**Amendments to the Drawings**

Applicants are amending the drawings as originally filed and are submitting Replacement Drawings in the form of Formal Drawings. The drawings are being amended: (1) to add reference numerals that were inadvertently omitted from the drawings as originally filed, (2) to revise the text in the drawings as originally filed so that the text is consistent with the specification as originally filed, and (3) to correct errors in the reference numerals. In particular, the following reference numerals are being added to Fig. 1 of the drawings as originally filed: 27, 42, 44, 46, 47, and 48, where reference numeral 27 was inadvertently omitted from the drawing and specification, and reference numerals 42, 44, 46, 47, and 48 refer to redundant elements corresponding to those referenced reference numerals by 22, 24, 26, 27, and 28 found in Fig. 1 as originally filed.

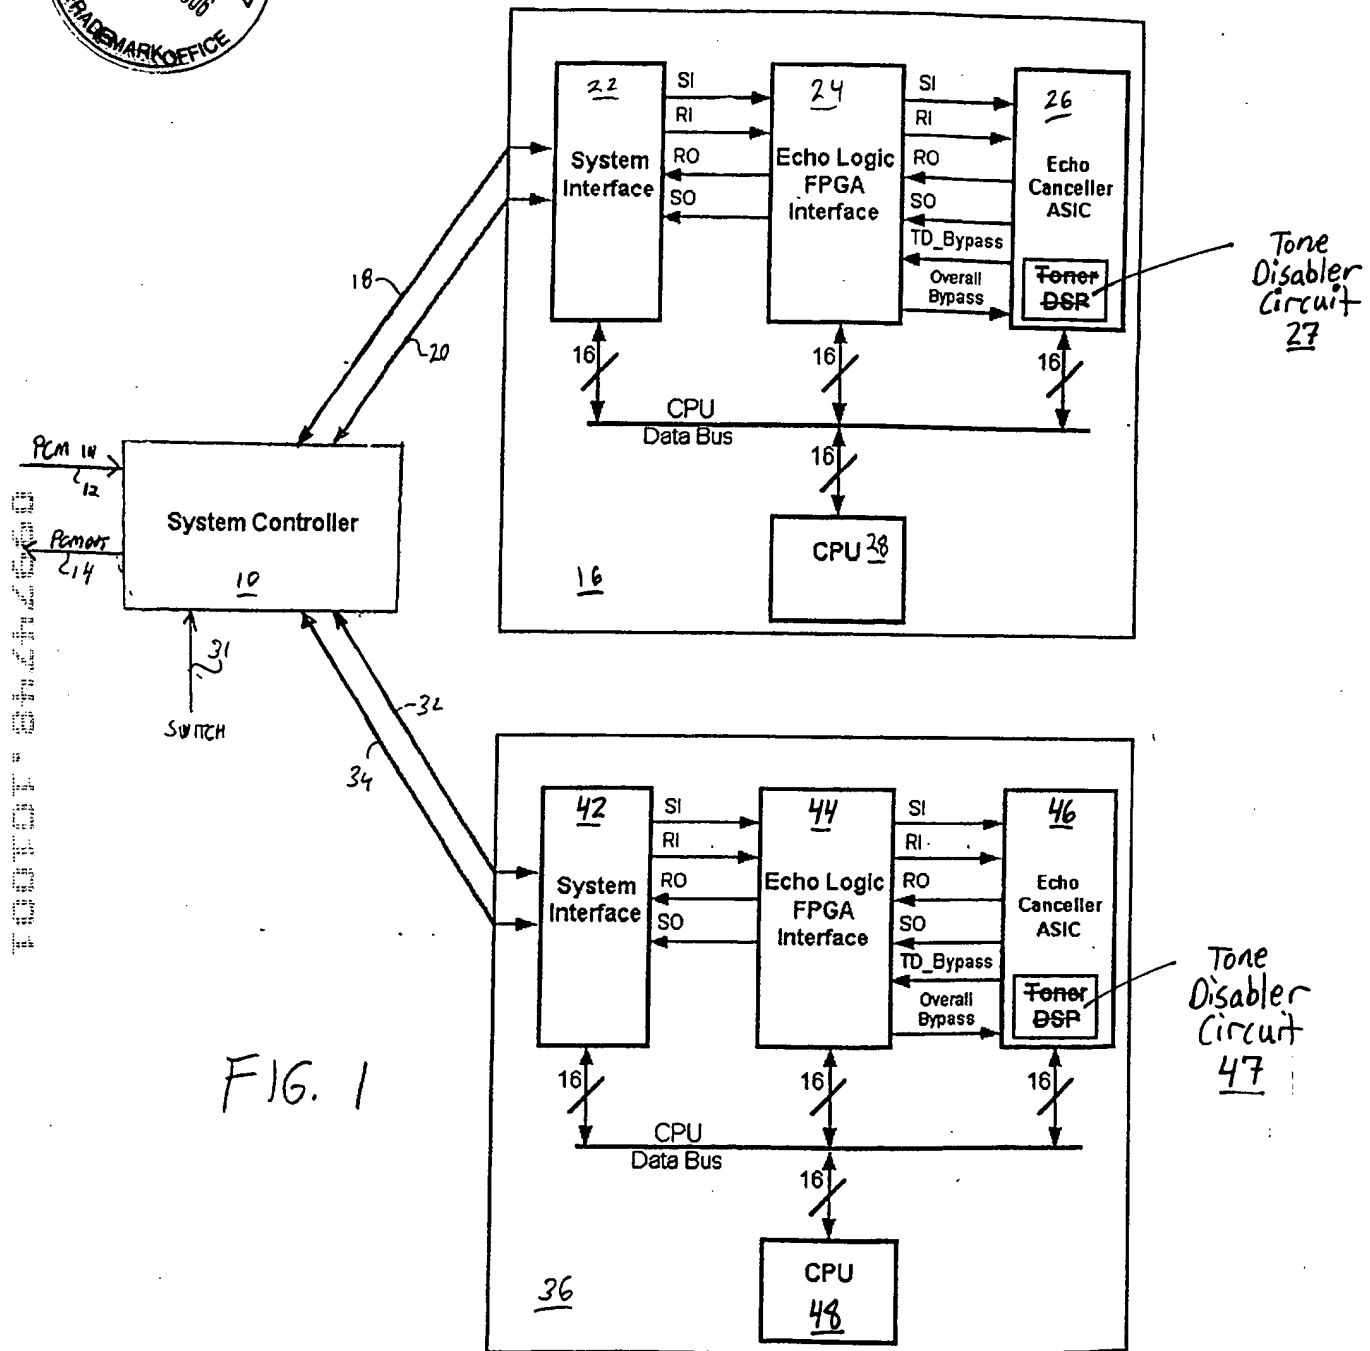
The phrase “Toner DSP” in Fig. 1 of the drawings as originally filed is being replaced with the phrase “Tone Disabler Circuit,” which is consistent with the specification as originally filed at least at page 5, line 17. Also, the terms “Echo”, “Toner”, and “Rcv” in Fig. 2 of the drawings as originally filed are being replaced with the phrases “Echo Filter”, “Tone Disabler Circuit”, and “Receive”, respectively. Support for these amendments is found in the specification as originally filed at least at page 5, line 1, page 4, line 16, and page 4, line 15, respectively. Finally, the reference numeral 64 in Fig. 2 of the drawings as originally filed, identifying the block including the text “MUX,” is being changed to reference numeral 65 so that it is not confused with the reference numeral 64 identifying the block including the text “Echo”.

In addition, Fig. 1 is now provided as Figs. 1A and 1B, and a legend located on the same page as Fig. 1A clearly provides a mapping. The specification, therefore, is believed to be consistent with the Replacement Drawings.
